ACCESSIBILITY REPORT
PROJECT APPLICATION

**CLARE HOTEL &
ADMINISTRATION
BUILDING**

**KENSINGTON LANE
SYDNEY**

1st November 2012

External Pathway Links & Building Entrances (Parts D3.2 & D3.3 of the BCA)

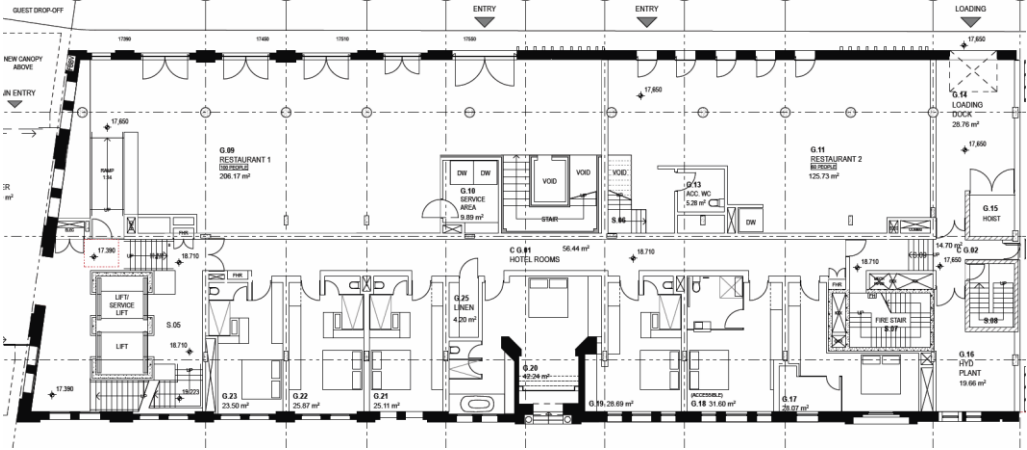
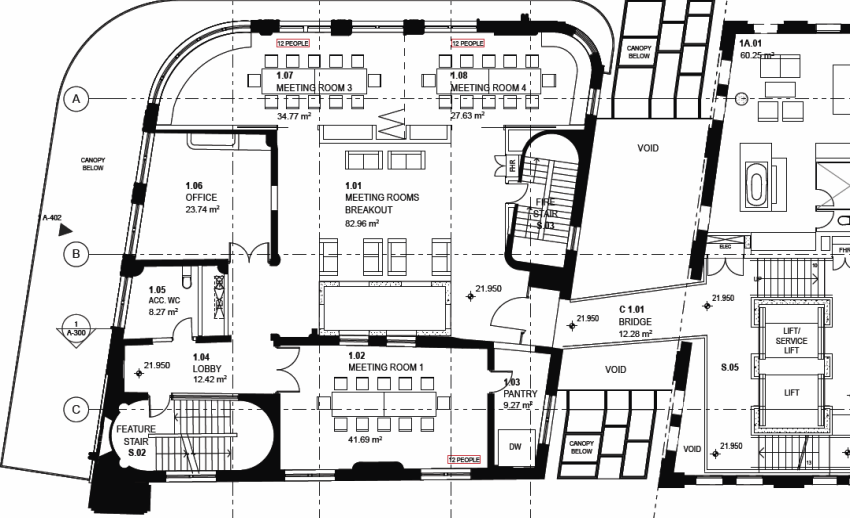
BCA / DDA Compliance	Complies
I. Ground Floor Foyer Entrance – The development proposes a new in-fill foyer area between the two buildings which will provide on-grade access from Kensington Lane and Carlton Street to a generally level entry landing and auto sliding doorways in accordance with AS1428.1 to comply with Part D3.2 of the	YES

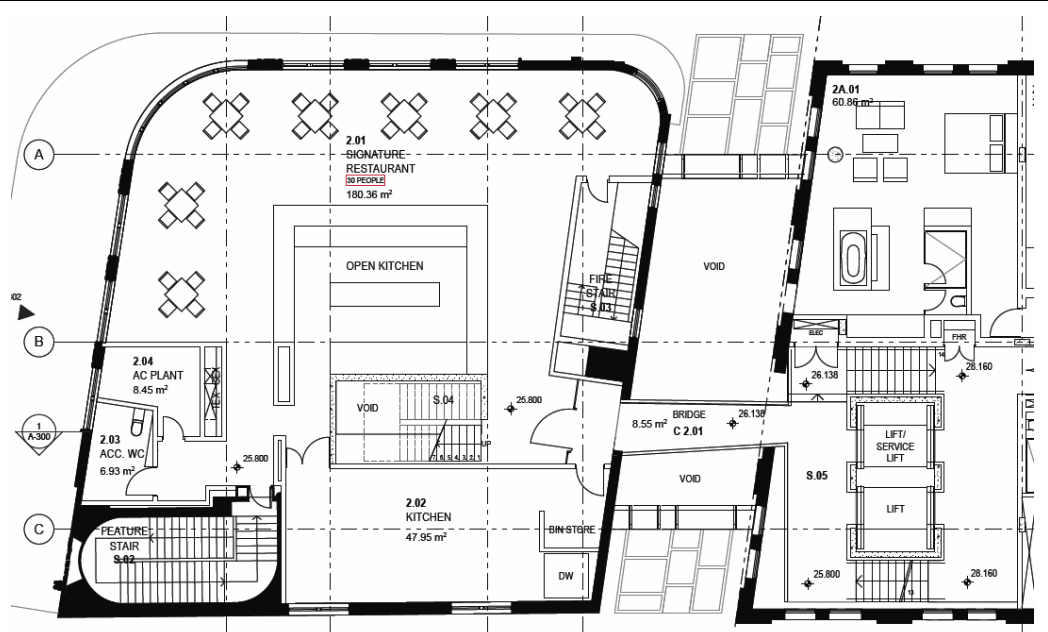
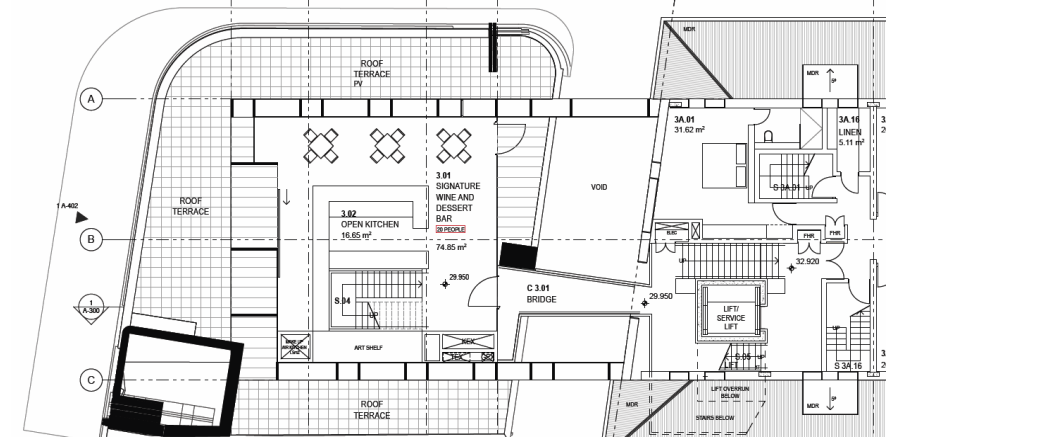
BCA / DDA Compliance	Complies
<p>BCA and DDA Access Code.</p> <p>2. Restaurant Entrances – The two restaurants within the Administration building shall provide level threshold entry access from Kensington Lane in accordance with AS1428.1 to comply with Part D3.2 of the BCA and DDA Access Code.</p>	YES
<p>3. The existing one step threshold entrances to the Clare Hotel from Broadway will incorporate signage to advise of the accessible main entrances from Kensington Lane and Carlton Street.</p> 	YES
<p>4. With regard to the doorway entrances the CC plans will provide details of door width, thresholds, luminance contrasting doorways and door hardware in accordance with AS1428.1 to facilitate appropriate access to comply with Parts D3.2, D3.3 of the BCA and the DDA Access Code accessibility requirements.</p>	YES at CC stage

Internal Circulation (Part D3.3 of the BCA)

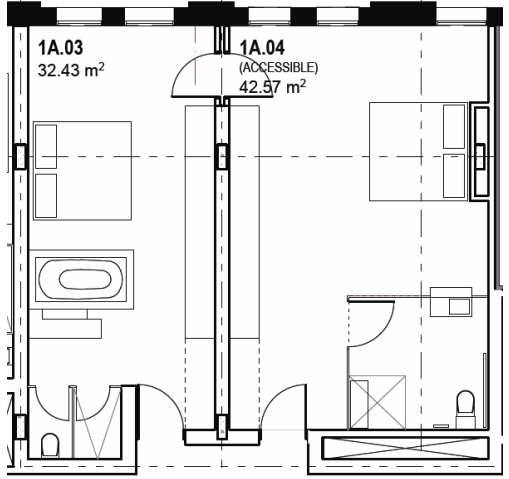
BCA / DDA Compliance		Complies
Ground Floor		
5. Ground Floor (Clare Hotel) – The ground floor area proposes an open plan entry foyer / Reception with level accessible paths of travel to the Lounge and Wine Display in accordance with AS1428.1 to facilitate appropriate access to comply with Part D3.3 of the BCA and the DDA Access Code.		YES
6. Ground Floor (Administration) – The ground floor area proposes an open plan entry foyer / lift lobby @RL17.390 with lifts that provide dual doors to		YES

BCA / DDA Compliance	Complies
<p>enable access to the intermediate ground floor level @RL18.710, which facilitates access to a 1600-1800mm width corridor to the seven accommodation suites on this level in accordance with AS1428.1 to facilitate appropriate access to comply with Part D3.3 of the BCA and the DDA Access Code.</p> <p>7. The plans also show new stairway links from the ground floor lobby to the upper ground level and basement level, which will be detailed at a future documentation stage in accordance with AS1428.1 and AS1428.4.1 to satisfy Parts D3.3 / D3.8 of the BCA and the DDA Access Code.</p>  <p>8. Restaurant 1 incorporates a ramp link from the lift lobby to RL17.650 with a single level throughout with no inherent access barriers. This restaurant incorporates stairway access and a dumb waiter lift to the back-of-house kitchen areas in the basement.</p> <p>9. Restaurant 2 provides a single level throughout with appropriate access to a unisex accessible toilet. This restaurant incorporates stairway access and a dumb waiter lift to the back-of-house kitchen areas in the basement.</p> <p>10. While the back-of-house commercial kitchen and plant areas are not required to be accessible due to the particular use, consistent with Part D3.4 of the BCA, alternate passenger lift access to the basement and the respective kitchen areas and staff facilities is available from the main lift lobby.</p> <p>11. Overall, the adaptive reuse design shall provide equitable access to all areas on the ground floor in accordance with AS1428.1, AS1428.4.1, AS173.5.12 to satisfy Parts D3.3 / D3.8 of the BCA and the DDA Access Code.</p>	<p>YES at CC stage</p> <p>YES</p> <p>YES</p> <p>YES</p> <p>YES</p>
